RESPONSE TO NRC LTR DTD 4/20/78 forwarding
addl info re subject facilities Fire
Protection Program...w/att

ENCLOSURE 1

Responses to Questions

Indian Point Unit No. 2

FIGURE 5-1
INDIAN POINT
STATION
ELECTRICAL ONE
LINE DIAGRAM

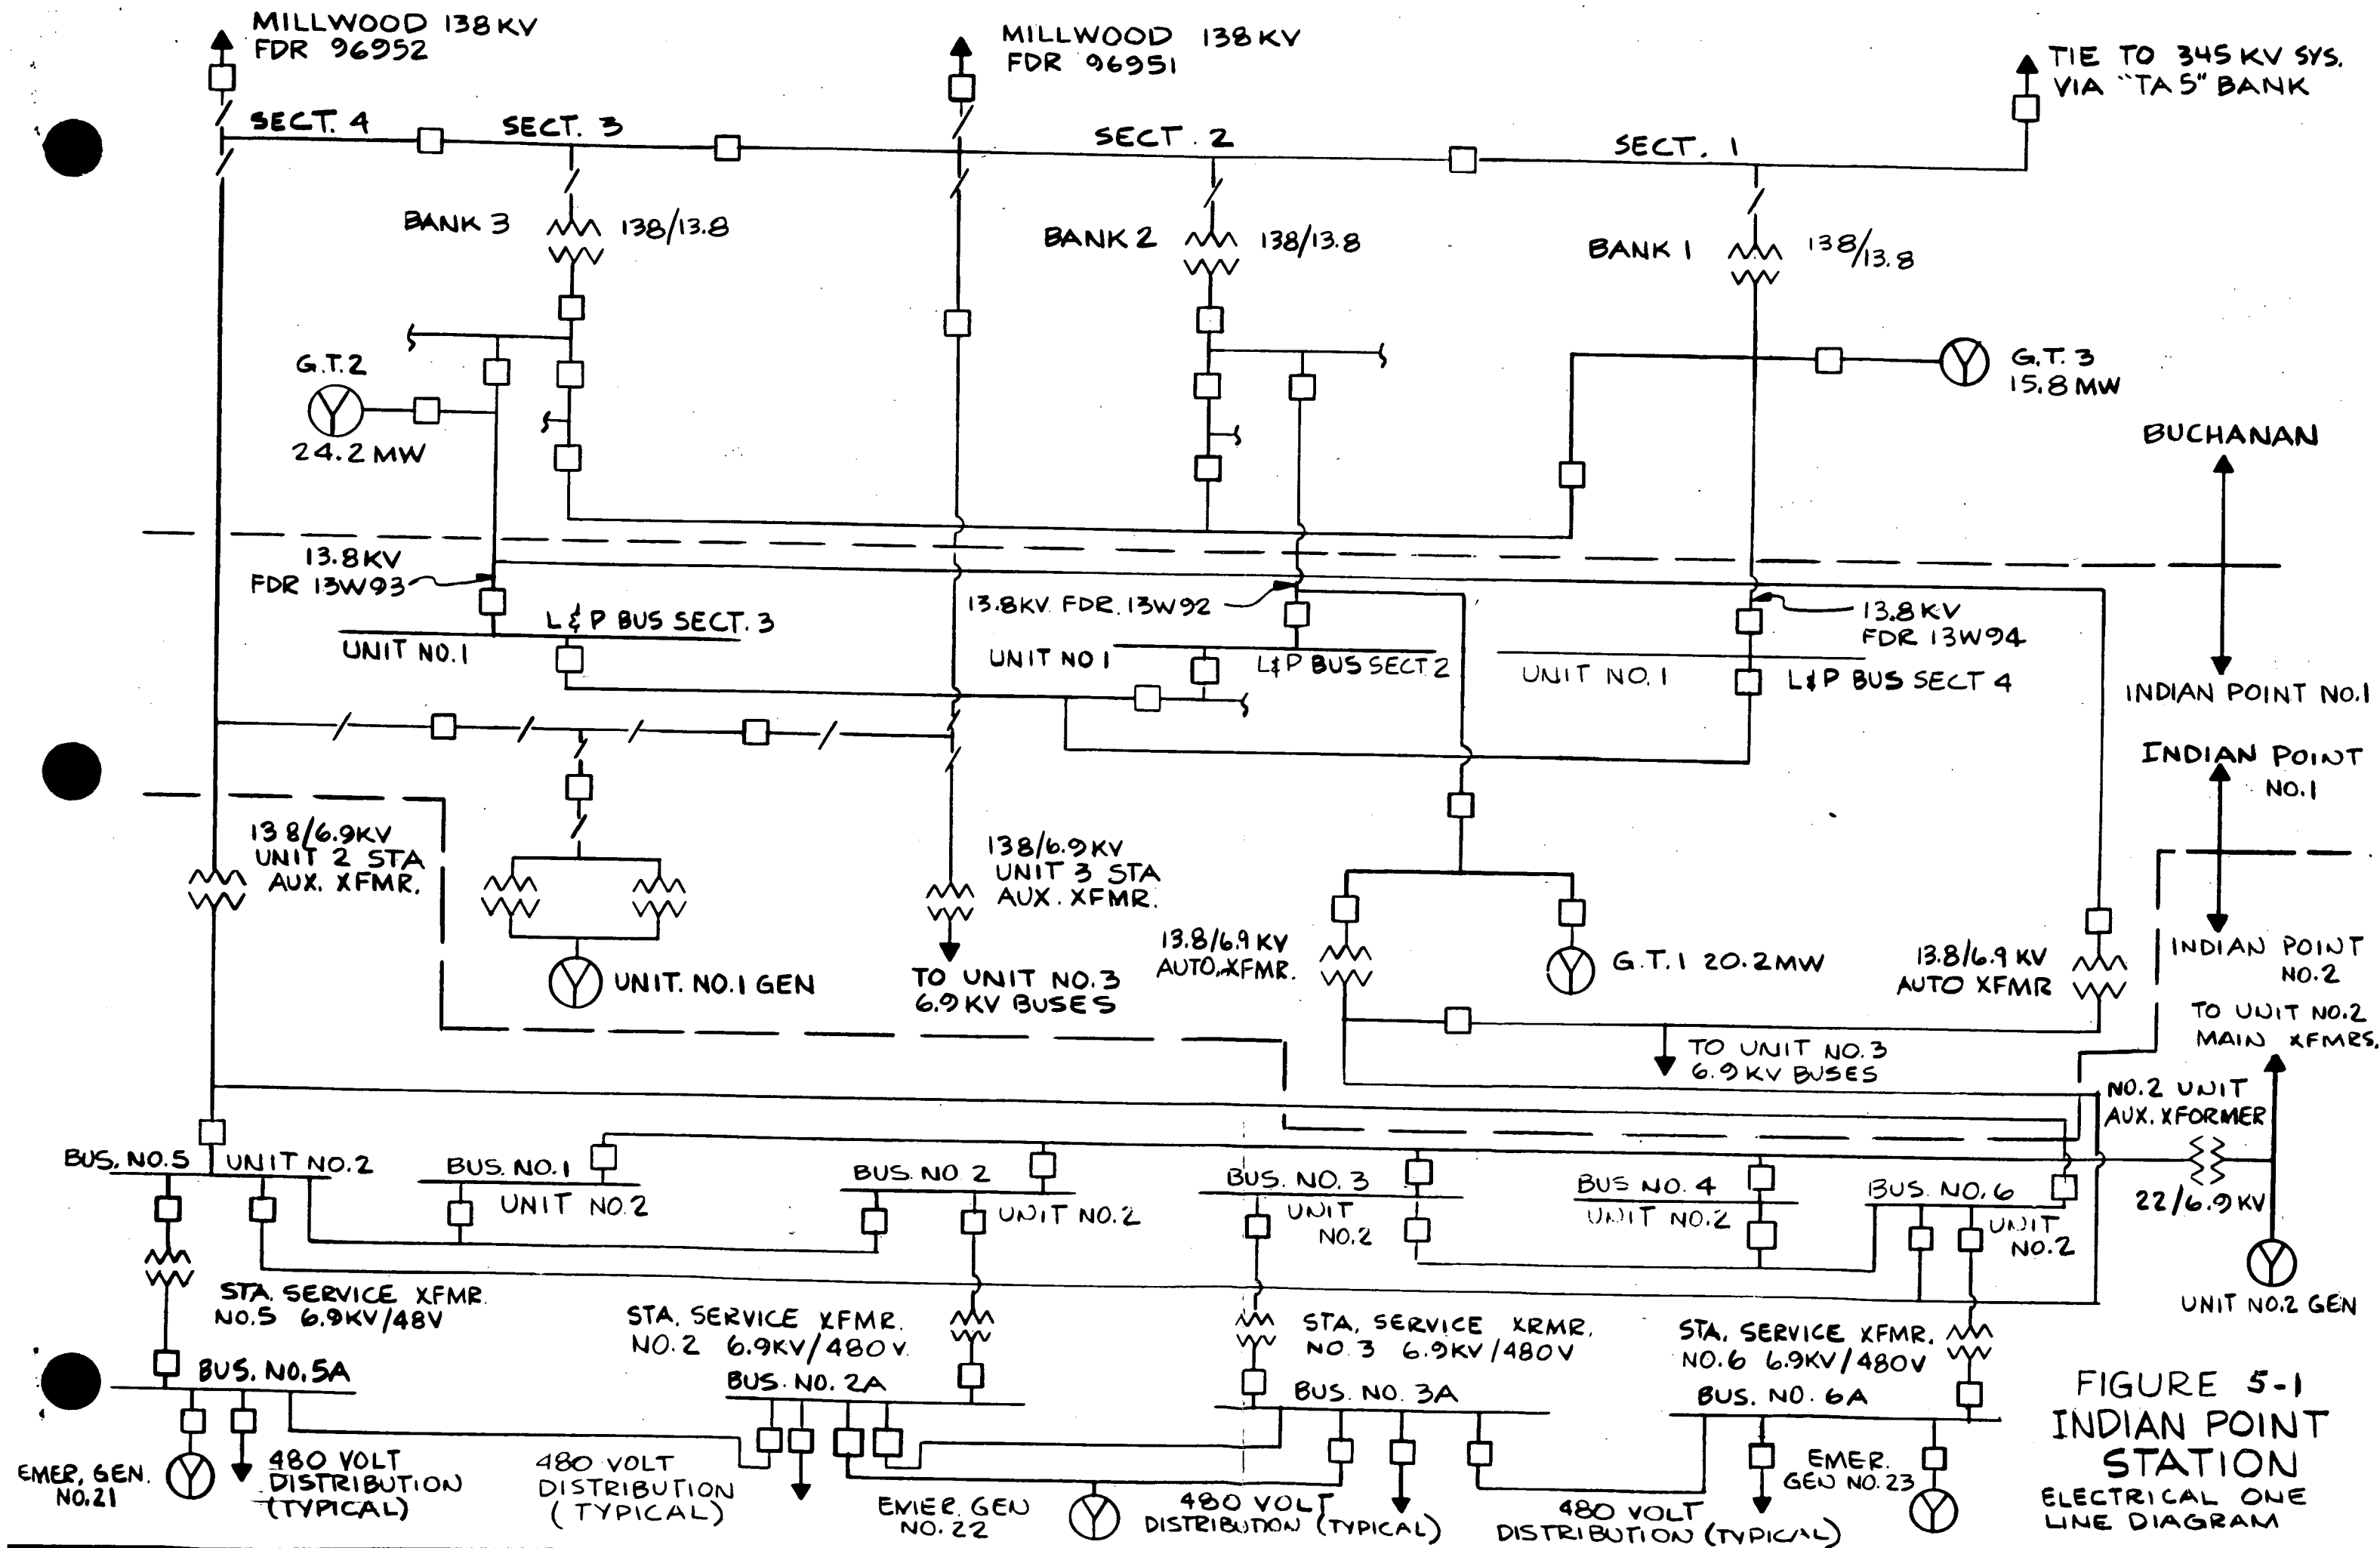
- a) In the fire zone discussions where the redundant emergency diesel generators are addressed, it is stated that these are "not required for safe-shutdown." Describe why these are not required for safe shutdown. Describe how safe shutdown conditions are achieved and maintained if offsite and station power is lost as a result of a fire.
- b) In fire zone 10 of Unit 2, a fire may result in loss of all three diesels, yet it is stated that there is no effect on safe shutdown. For such a fire, indicate whether either normal or offsite power is required to maintain safe shutdown conditions. Provide an evaluation of the consequences of such a fire if both normal and offsite power are lost as a result of the fire. It is our position that credit for normal or offsite ac may not be taken for shutting down a unit during or following a fire. Identify where such credit may have been taken.

In evaluating the consequences of a fire in the Diesel Generator Building, the simultaneous loss of offsite power was not considered to be a credible event. We do not agree with the Staff's position that credit for normal or offsite power may not be taken for shutting down the unit during or following a fire. The design of the system (Figure 5-1) is such that sufficient independence and isolation between the various sources of electrical power is provided in order to guard against concurrent loss of all auxiliary power. In addition, the guidelines for fire protection, as stated in Section A.4 of Branch Technical Position 9.5-1 Appendix A, does not require the consideration of a fire and the most severe natural phenomenon occurring concurrently. The dual event of a fire and loss of offsite power is contrary to this guideline.

Offsite power is supplied to Unit 2 by two 138kv overhead transmission lines and two 13.8kv underground feeders from the

Buchanan Sub-Station. Each of the 13.8kv feeders is backed up by a gas turbine with black start capability.

The Buchanan Sub-Station has two connections to the Con Ed Millwood Switching Station and a connection to the Buchanan 345kv yard. Power from the sub-station is supplied to the Unit No. 2 Station Auxiliary Transformer via Feeder No. 95332 or via Feeder 95331. Interconnection between the feeders is provided by an onsite switching station located adjacent to the Unit 1 Conventional Building.

During normal operation the Station Auxiliary Transformer provides power to two (No. 5 and 6) of six 6.9kv buses. The remaining four buses (No. 1, 2, 3, and 4) are supplied from the Unit Auxiliary Transformer. Buses 5 and 6 can also be supplied through the 13.8kv/6.9kv system. Bus tie breakers, connecting bus 5 to bus 1, bus 5 to bus 2, bus 6 to bus 3 and bus 6 to bus 4 are provided for start-up, shutdown, hot standby and emergency conditions.

Two 13.8kv underground feeders supply power to onsite substations where it is stepped down to 6.9kv by individual transformers. While each of the feeds is normally assigned to one of the Units (No. 13W92 for Unit 2 and 13W93 for Unit 3), interties at the sub-stations permit the crossfeeding from any line to any unit; again providing the diversity and independence between the various sources to guard against concurrent loss of all auxiliary power. A third 13.8kv underground feeder to Unit No. 1 (No. 13W94) can also be utilized to supply power to Units 2 and 3 through switching at the Buchanan Sub-Station.

Tied into each of the three 13.8kv feeders are three gas turbines rated at 20.2MW (Feeder 13W92), 24.2MW (Feeder 13W93), and 15.8MW (Feeder 13W94). Two of the turbines are located near the Buchanan Sub-Station while the third is onsite at Unit No. 1. All of the turbines have black start capability to permit usage even in the event of a total system failure.
